## **ADDENDUM #2**

DATE: September 16, 2016

TO CONTRACT DOCUMENTS ENTITLED: Biotech Connector  
1901 N. 21<sup>st</sup> Street  
Lincoln, Nebraska

**E2.04**

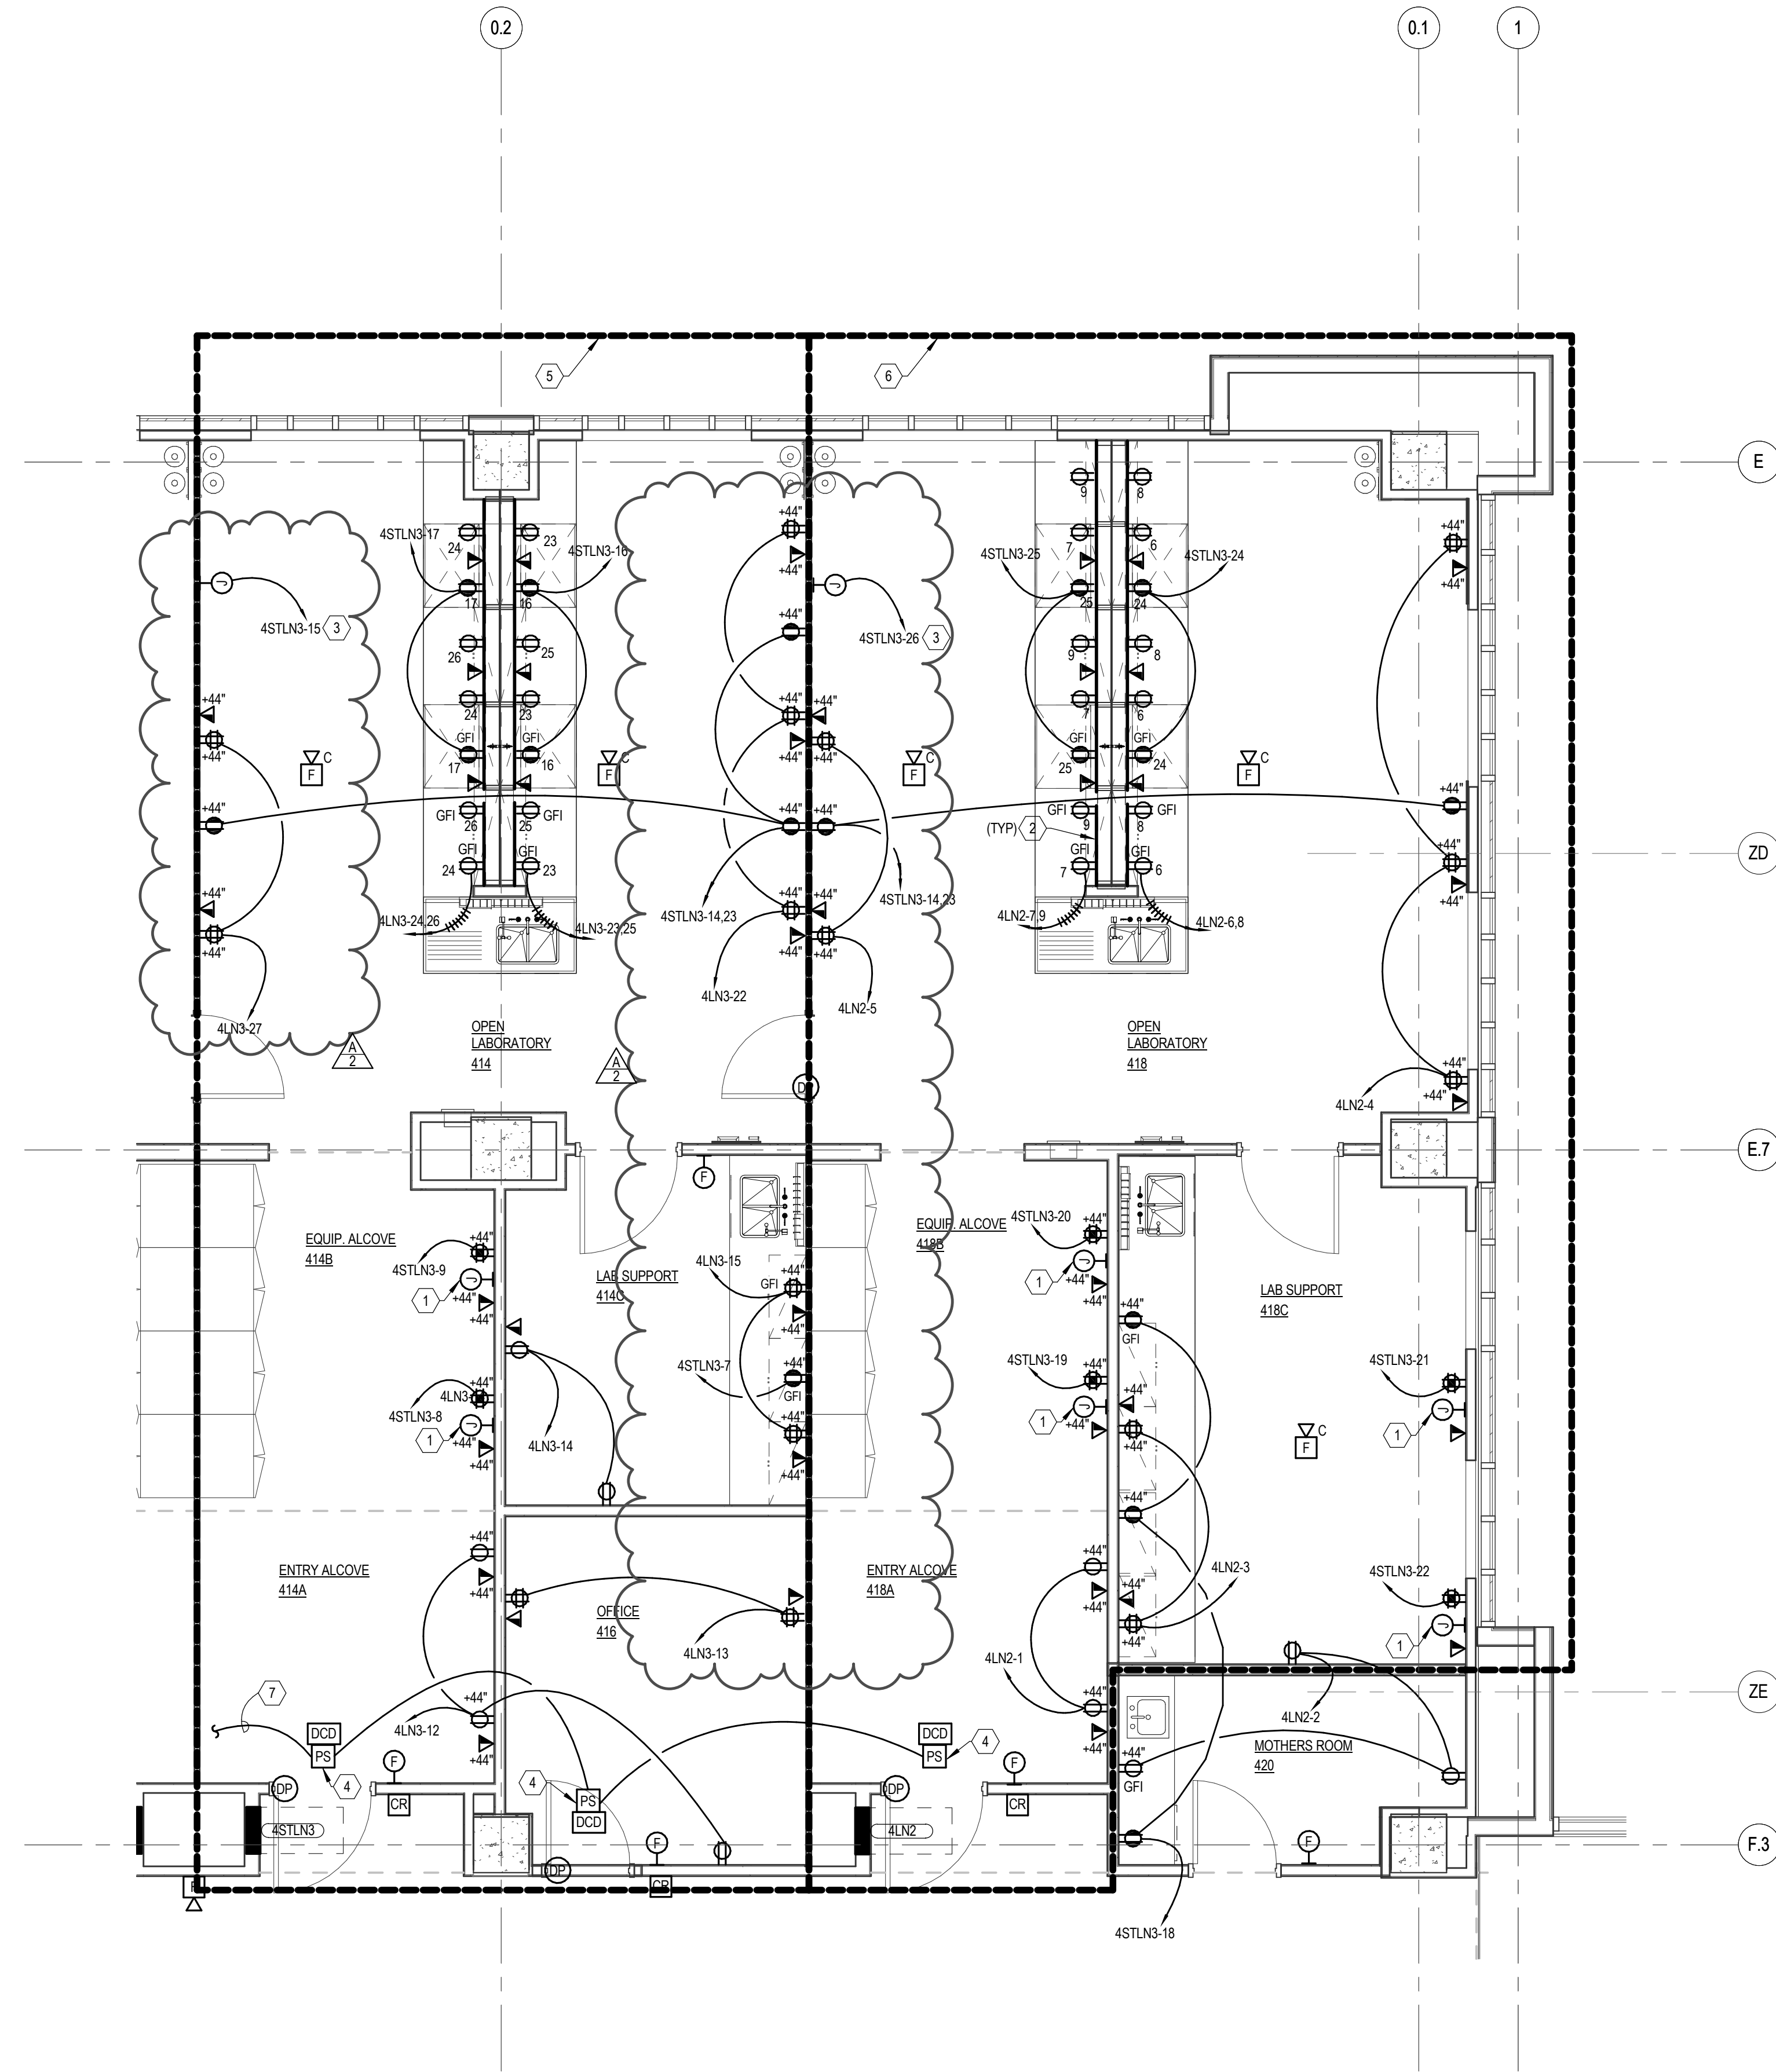
Surface mounted devices have been recessed in demountable walls. See the attached sheet E2.04 for additional information.

IF ALTERNATE #6 IS ACCEPTED, ALL SERVICES SHOWN IN DEMOUNTABLE WALLS SHALL BE RECESSED.
